Re: Impact Area Groundwater Study Program (IAGWSP), Final Northwest Corner
Environmental Monitoring Report, June 2011 through June 2012, dated February 2013

Northwest Corner Environmental Monitoring Report June 2011 through June 2012

**Camp Edwards
Massachusetts Military Reservation
Cape Cod, Massachusetts**

TITLE
Northwest Corner
Environmental Monitoring Program
RDX Plumes
June 2011 and June 2012

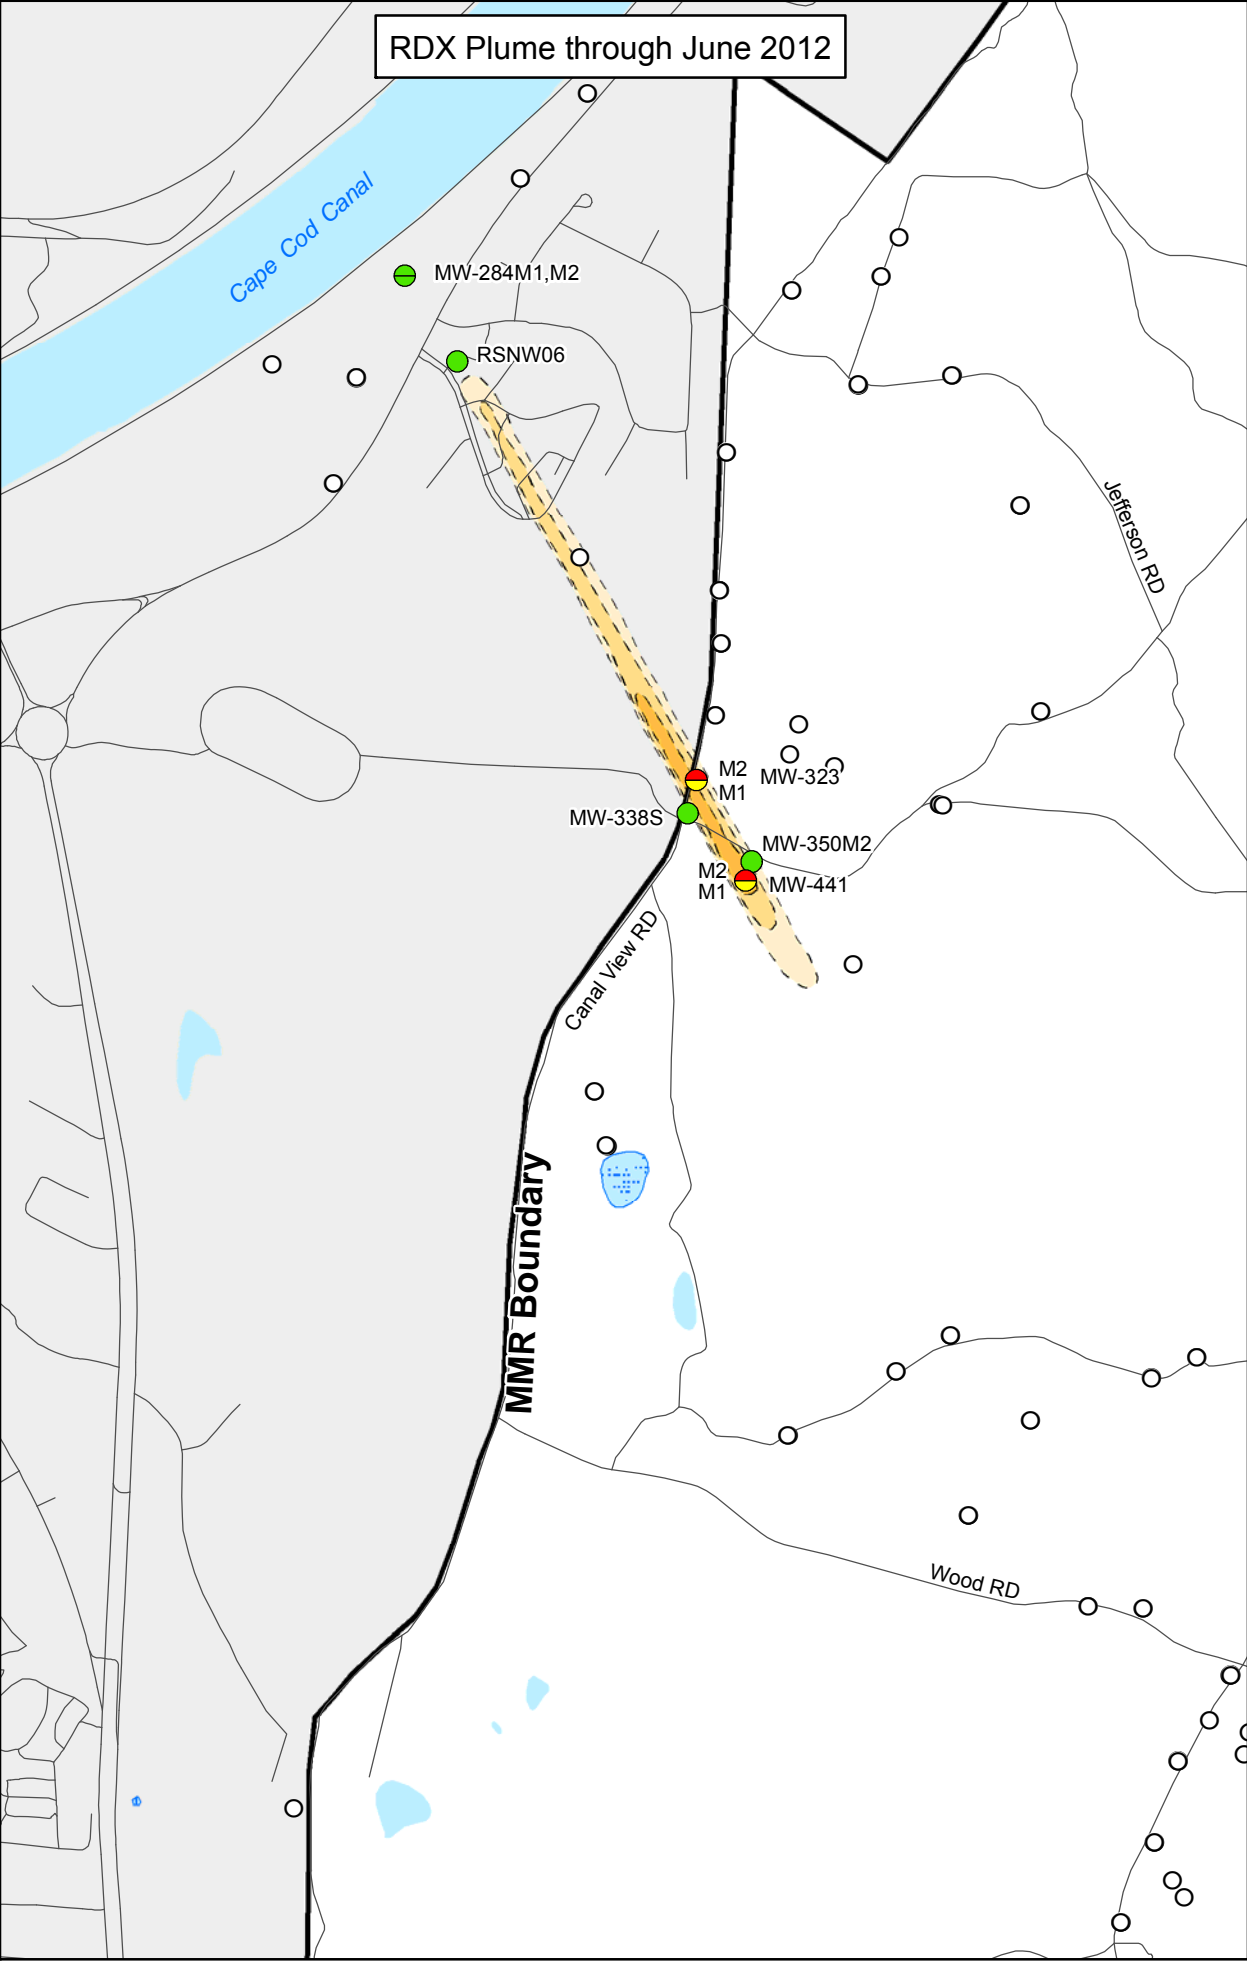
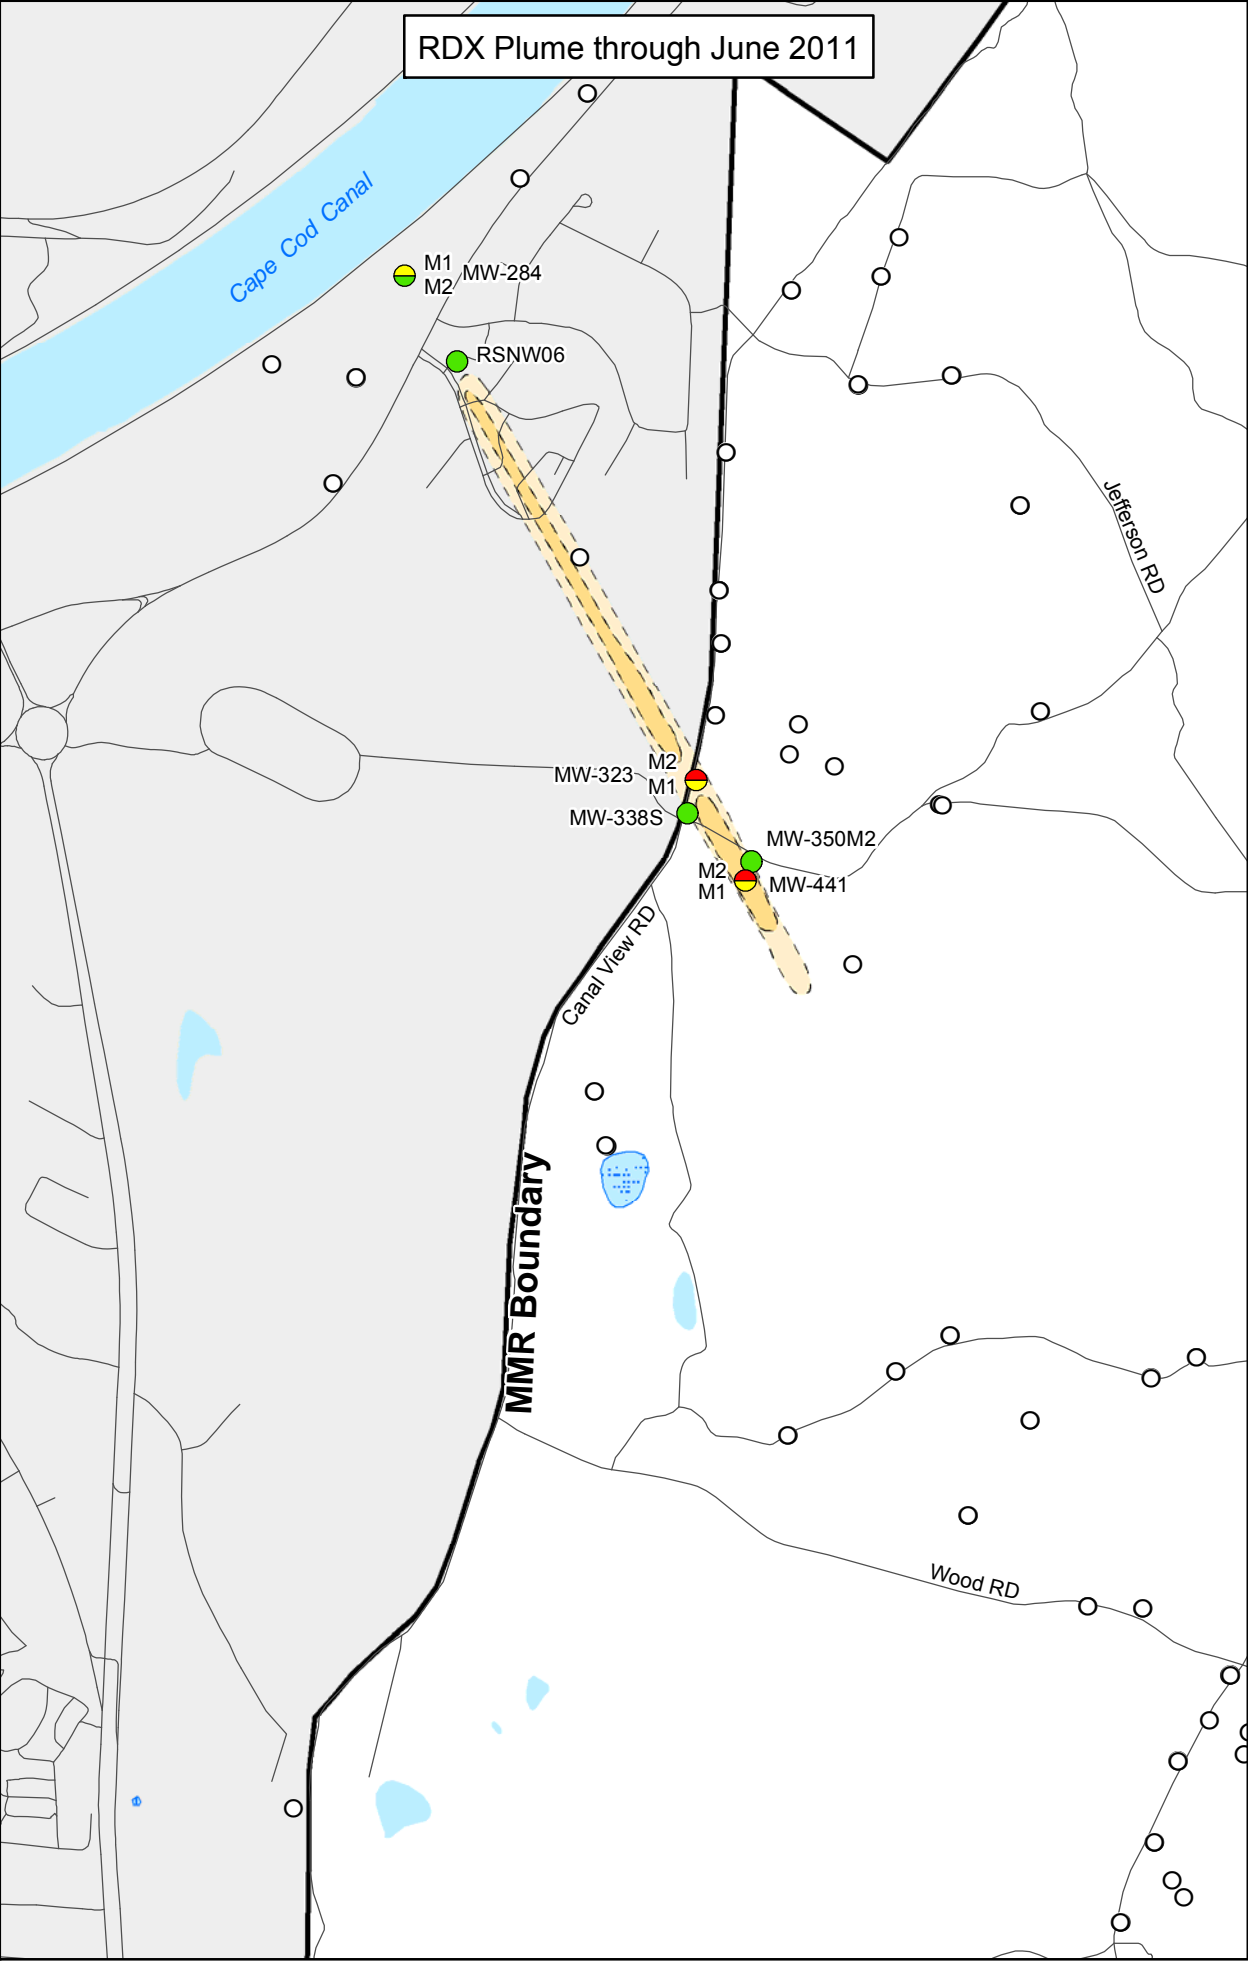
The text states, “**A comparison between the RDX plume contoured with data through June 2011 and through June 2012 is presented in Figure 4-2.**” MassDEP notes that the headings for the 2011 and 2012 RDX plume depictions in Figure 4-2 appear to be switched (i.e. 2011 heading on 2012 RDX distribution and vice versa). Also, the RDX shading on the illustration of the RDX plume through June 2012 in Figure 4-2 should be revised in the vicinity of MW-441M2 to reflect the RDX concentration of 11 µg/L that was detected in this well in May 2012.

Based on concentrations in these three wells being below the RBC of 0.6 µg/L, the 0.6 µg/L iso-contour on Figure 4-1 was drawn slightly upgradient of RSNW06. Additionally, the 2 µg/L contour has been slightly adjusted to exclude MW-323M2. A comparison between the RDX plume contoured with data through June 2011 and through June 2012 is presented in Figure 4-2.

Response: Figure 4-2 is not labeled incorrectly. The left pane is the RDX depiction through June 2011 and the right pane is the RDX plume depicted through June 2012. Furthermore, in the right pane well MW-441M2 is depicted in the RDX contour from 6 to 20 µg/L, and respects the 11 µg/L RDX concentration detected in May 2012.

FIGURE
4-2

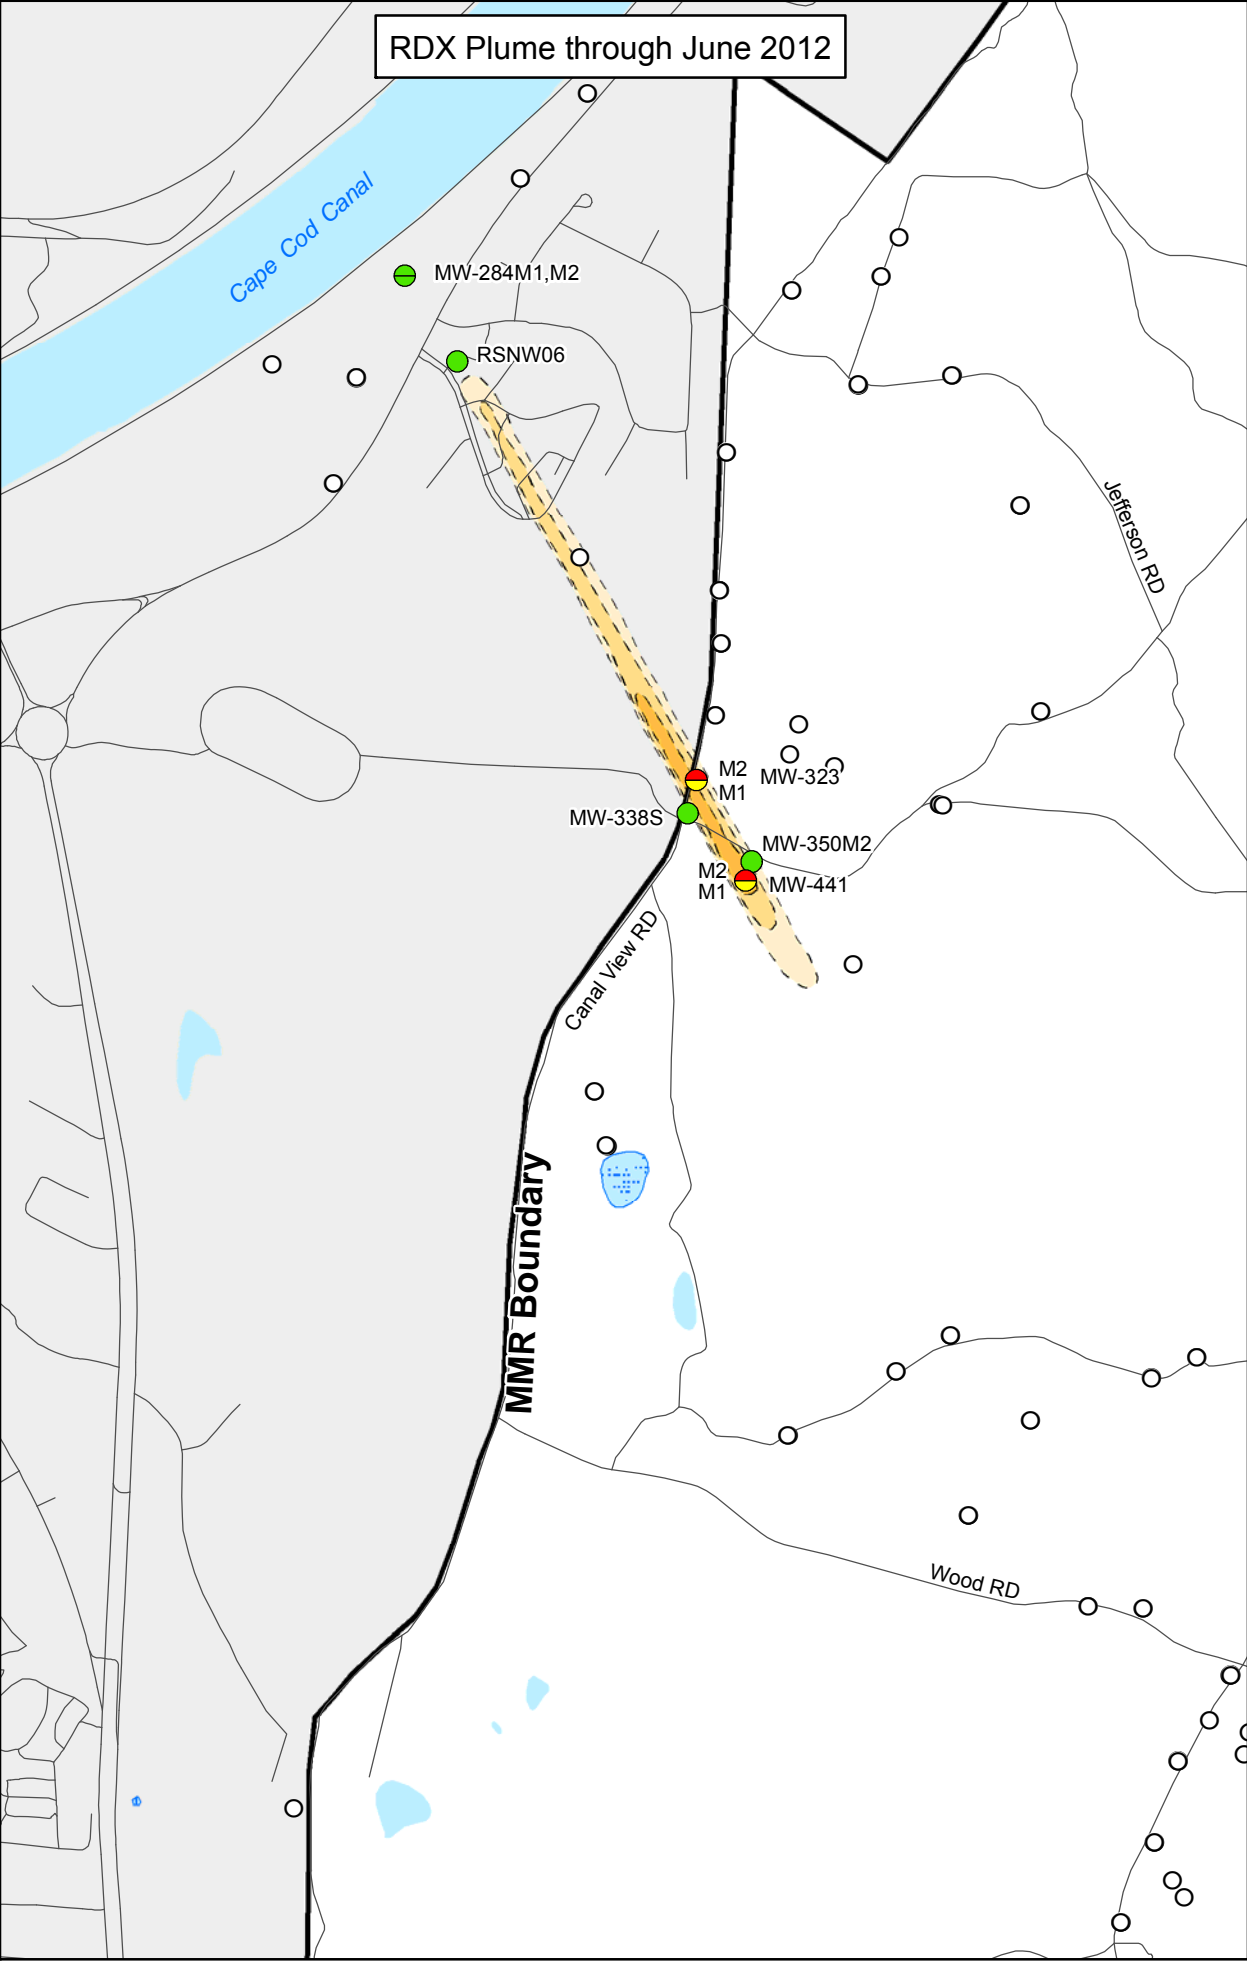
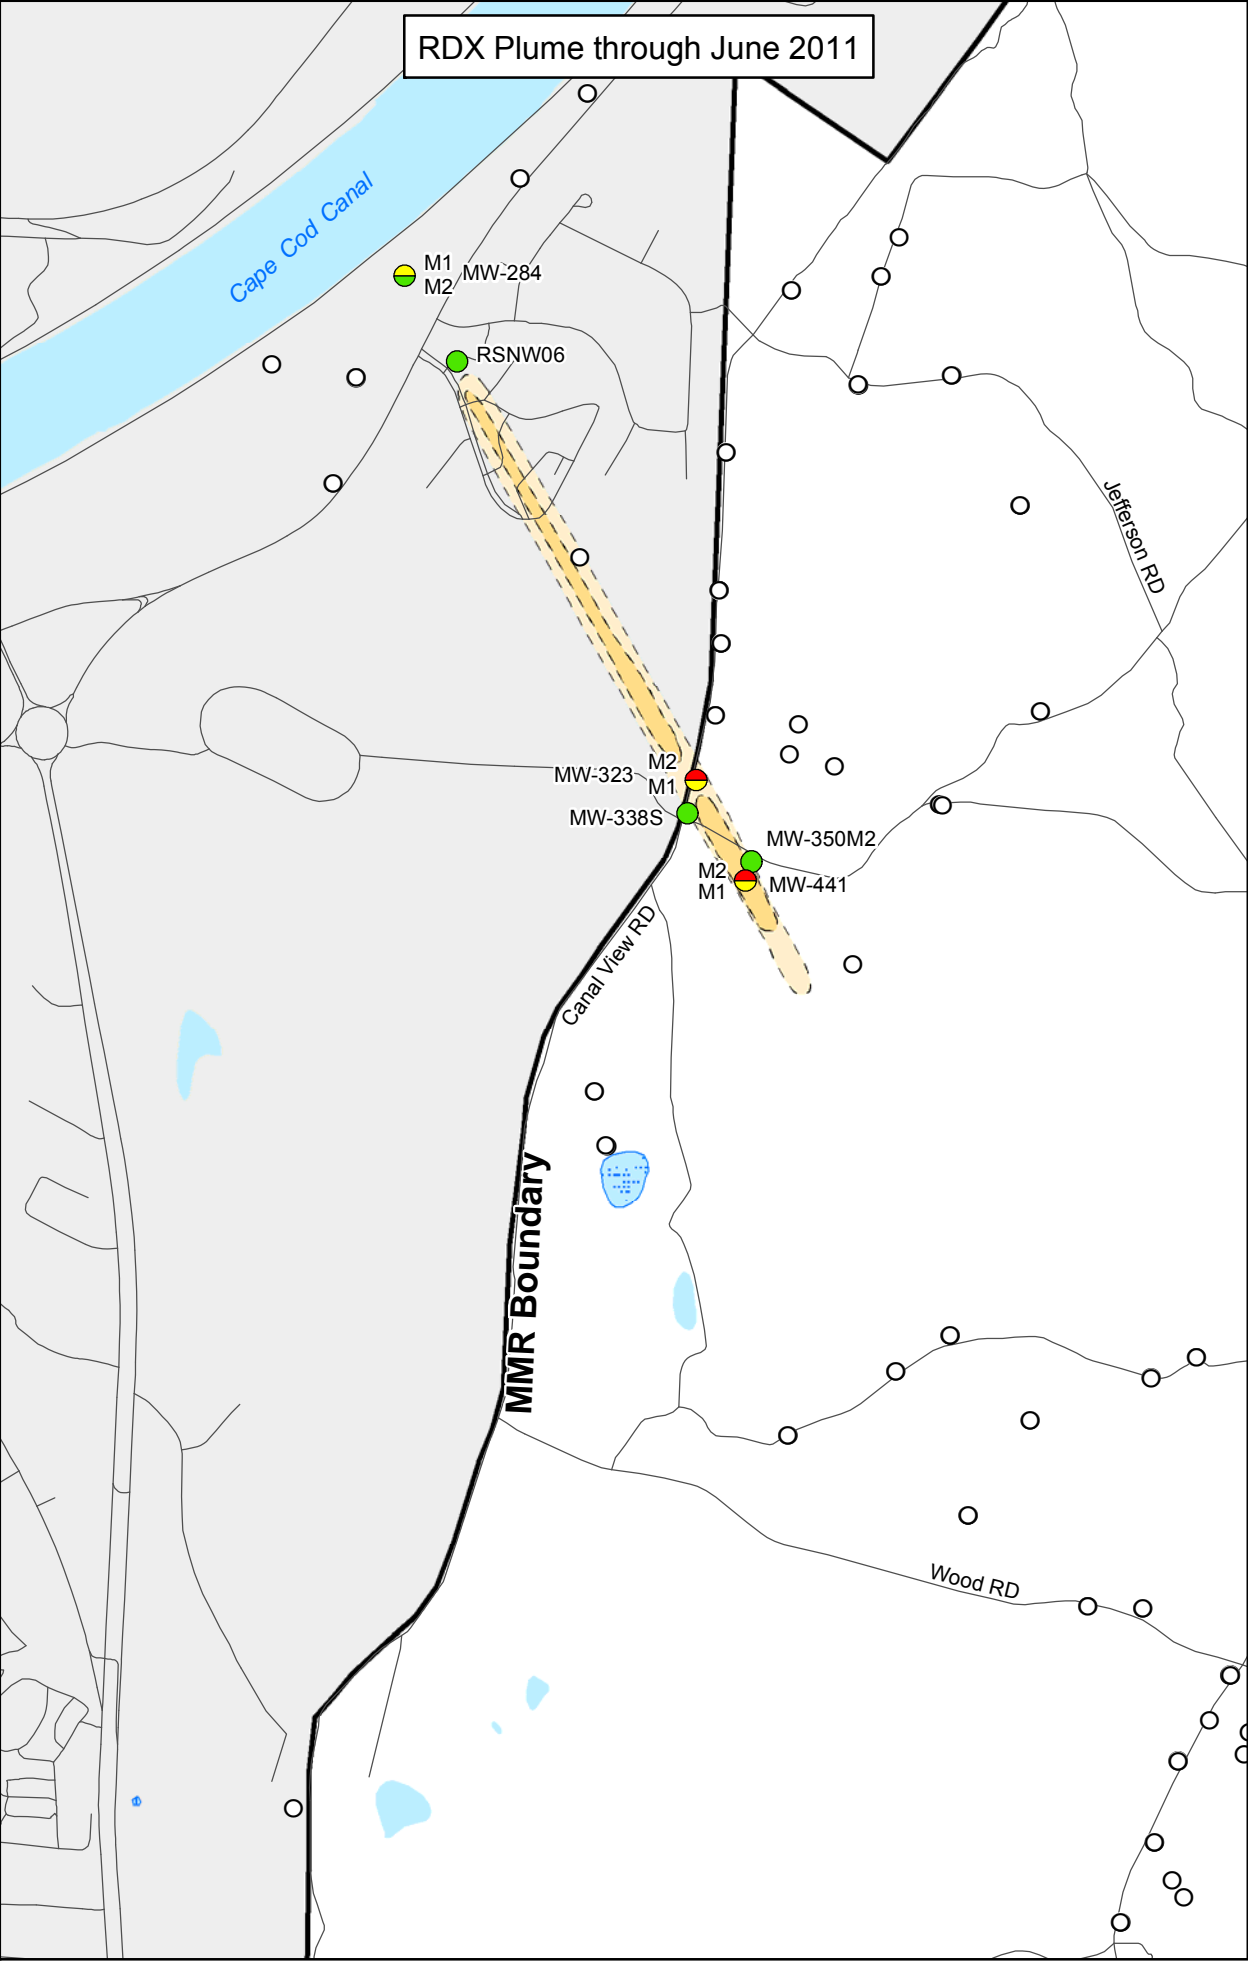
Additional Comment: Further clarification of the figure is requested.

Resolution: Based on groundwater flow direction coupled with RDX contaminant trends depicted in Figure 4-1, it is believed that the plume width as depicted in Figure 4-2 does not hold true to the non-detect concentrations measured in wells MW-338S and MW-350M2. The RDX plume was redrawn, see attached, so that the 0.6 µg/L and internal contours adhere to these non-detects.
